Access Compliance Report

Public Rights-of-Way

(Curb Ramps)

| Intersection ID: 3425 | Main Street: ISLAND_COVE_LN | Cross Street: OVERLOOK_MOUNTAIN_DR | Location: NE |

| ADA ID: 7DBD3BC524F1 | Ramp Type: Perp | Initial Pass/Fail: Pass | Overall Compliance: No |

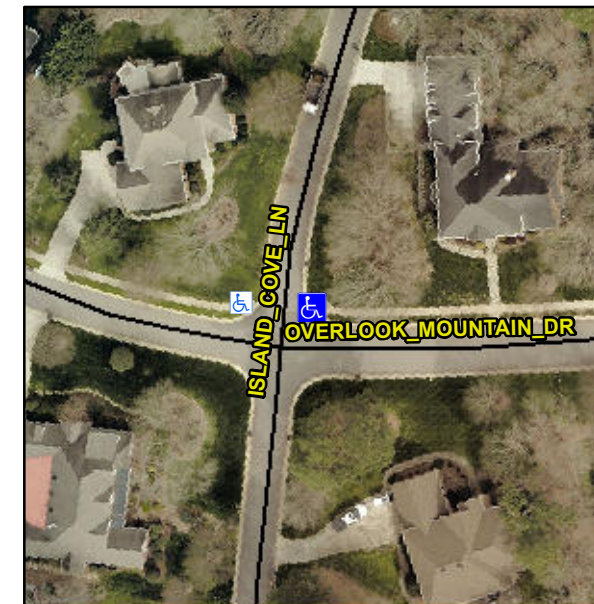
**Not Found, R304.2.1, R304.2.2-Perp,
R304.3.2-Para, R304.5.3, R305.2,
R304.5.4**

| Compliance | Description | Data | Compliance | Description | Data |
|------------|-----------------------|--------|------------|-----------------------------|------|
| No | Landing Length (in) | N/A | Yes | DWS Provided? | Yes |
| No | Landing Width (in) | N/A | Yes | DWS Contrast? | Yes |
| No | Landing Slope (%) | N/A | Yes | DWS Length (in) | 24.0 |
| No | Landing X Slope (%) | N/A | Yes | DWS Full Width? | Yes |
| N/A | Landing Curb? (Y/N) | No | No | DWS Offset (in) | 3.0 |
| Yes | Gutter Ponding? | No | No | Gutter Slope (%) | 6.5 |
| Yes | Gutter Lip Ht (in) | 0.0 | No | Gutter X Slope (%) | 2.1 |

**Remove & Replace Entire Ramp.
Remove & Replace Gutter.**
